3.5 Missile Protection

The information in this section of the reference ABWR DCD, including all subsections, tables, and figures, is incorporated by reference with following departure and supplements.

STP DEP 3.5-1 (Table 3.5-1 and Figure 3.5-2)

Figure 3.5-2 Low-Trajectory Turbine Missile Ejection Zone

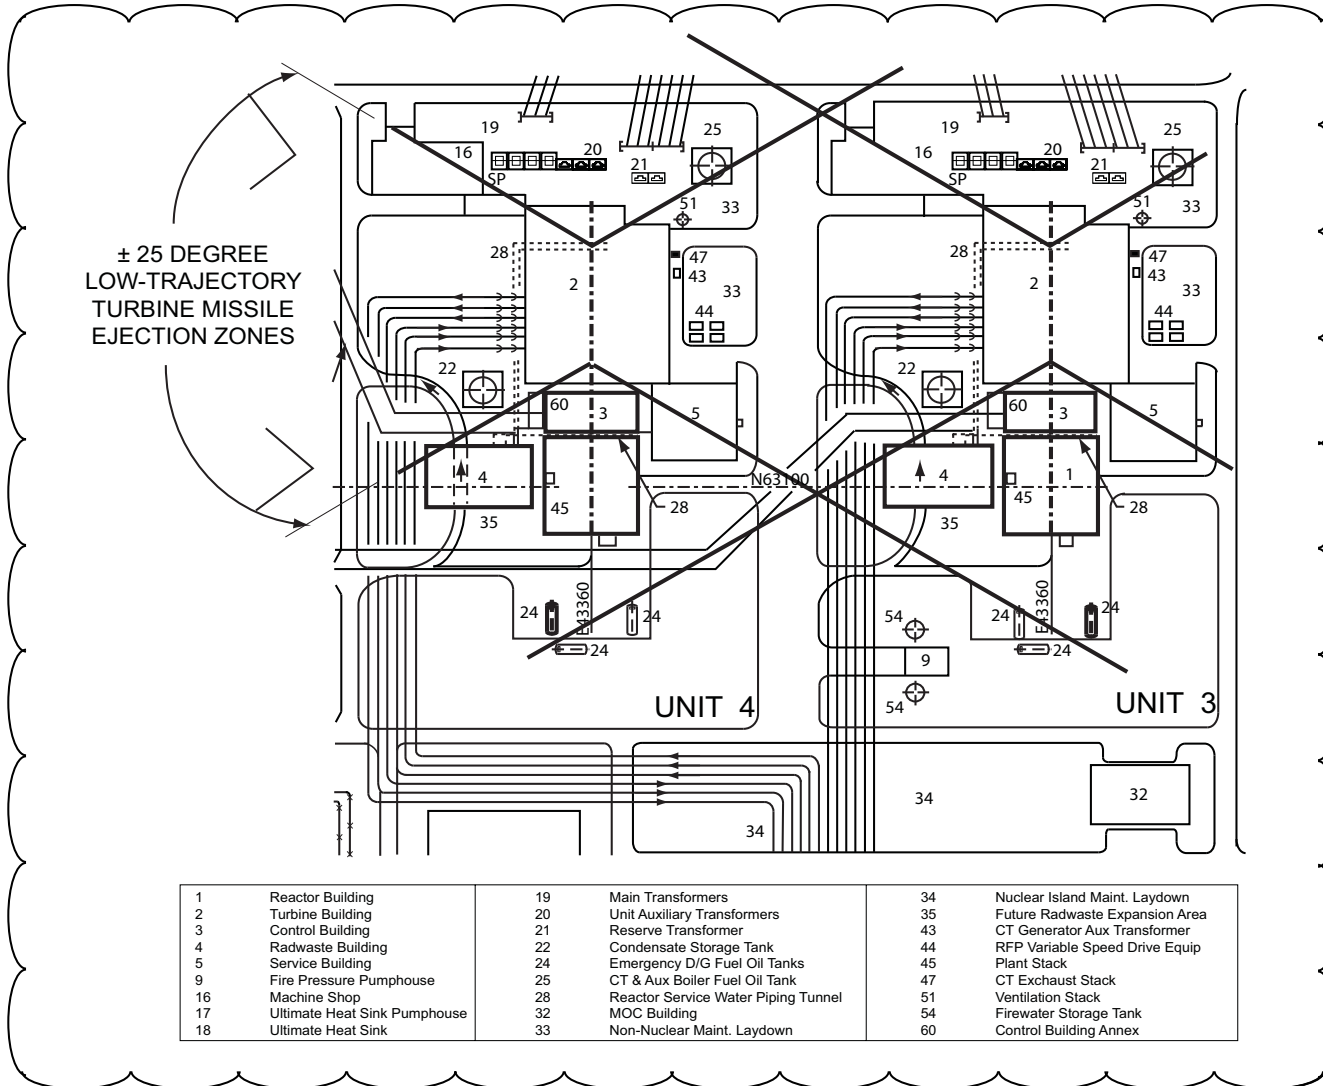
~~Acceptance Criteria 1 of SRP Section 3.5.1.3 considers a plant with a favorable turbine generator placement and orientation and adhering to the guidelines of Regulatory Guide 1.115 adequately protected against turbine missile hazards. Further, this criterion specifies that exclusions of safety-related structures, systems or components from low trajectory turbine missile strike zones constitutes adequate protection against low trajectory turbine missiles. The turbine generator placement and orientation of the ABWR Standard Plant meets the guidelines of Regulatory Guide 1.115 as illustrated in Figure 3.5-2.~~

The STP 3 & 4 turbine generator placement and orientation in relation to essential systems of the adjoining unit are illustrated on Figure 3.5-2. Per Regulatory Guide 1.115, the STP 3 & 4 turbine generator placement and orientation is considered unfavorable. Per Acceptance Criteria 1 of Standard Review Plan Section 3.5.1.3 for unfavorable turbine generators, a value of 10^{-2} per year per plant was chosen as a conservative value for the product of strike probability (P_2) and damage probability (P_3). The criteria for unfavorable turbine generator orientation given in Standard Review Plan Table 3.5.1.3-1 and provided in Table 3.5-1 was assumed for the missile generation probability (P_1). The resulting probability of unacceptable damage from a main steam turbine missile (P_4), which is $P_1 \times P_2 \times P_3$, is less than 10^{-7} per year per plant.

Therefore STP 3 & 4 main steam turbine generator placement and orientation meets the acceptance criteria of Standard Review Plan 3.5.1.3 and the guidelines of Regulatory Guide 1.115.
